ZEB Macquarie Park Bus Depot

REF submissions report

September 2024

Figure 1-2: Key features of the proposal - indicative only, subject to change during detailed design

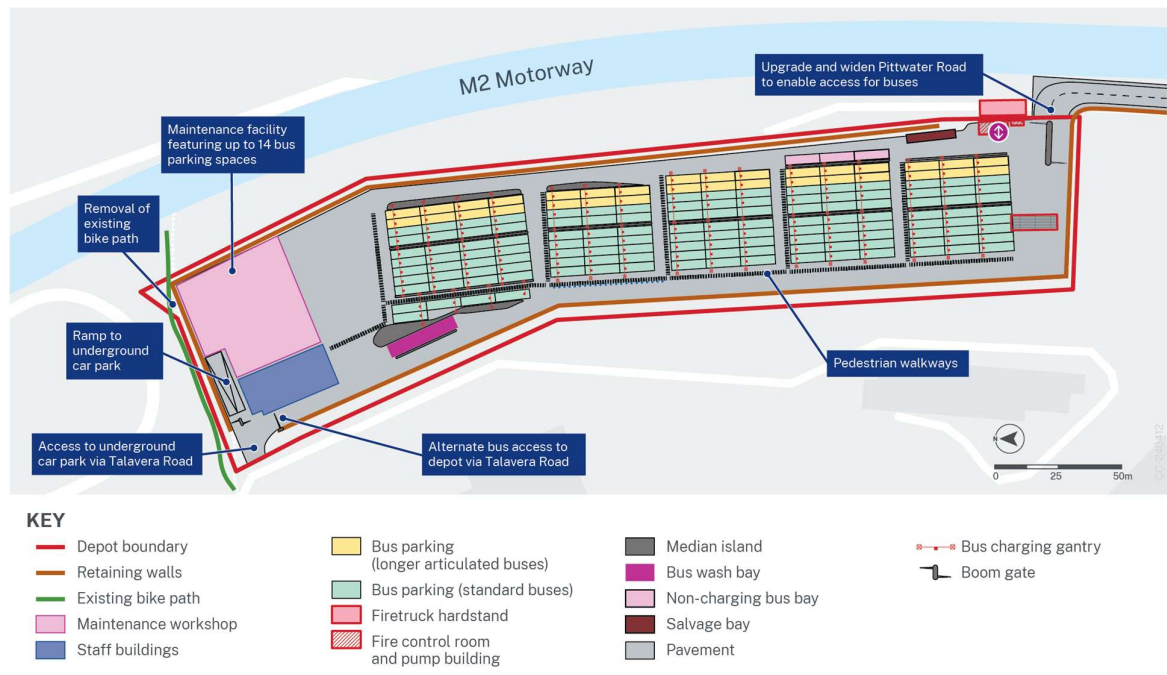
- a) More information sought on proposal location and bus entry/exit
- a) Clarification sought on whether there will be adequate site security during construction and operation and whether this will impact neighbouring security
- b) Request for more detail to understand the drainage and retaining walls interfaces
- c) Confirm no adverse geotechnical effect on the batter slopes/third party road assets, including the M2 and on-ramp bank slopes, arising from the construction of the proposal

Buses will access the depot via Pittwater Road, to the southeast of the site (Figure 1-2). Buses will need to travel along Wicks Road to access Pittwater Road.
